NIDEC MOTOR CORPORATION 09-Feb-16

REVISION RECORD FOR: ECO: E24810

TITLE	CODE	ITEM NO.	REV	SHEET NUMBER	DWG SIZE
CUSTOMER DETAIL DRAWING	V02	804121	D	1 OF 4	B

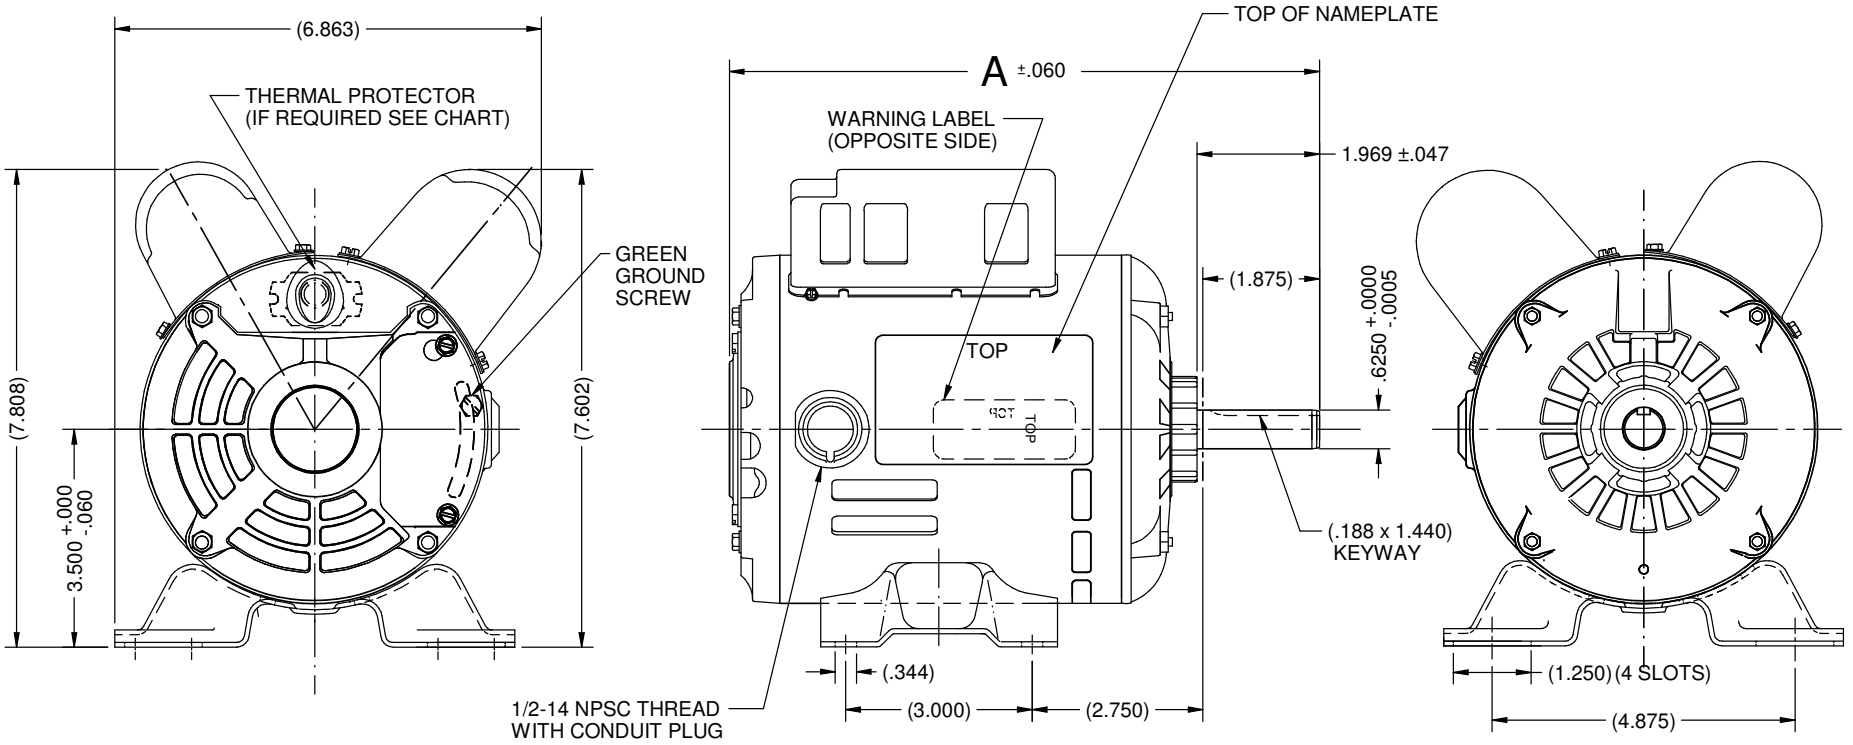
CHANGE AMPERES FROM "6.4/3.2" TO "5.0/2.6"
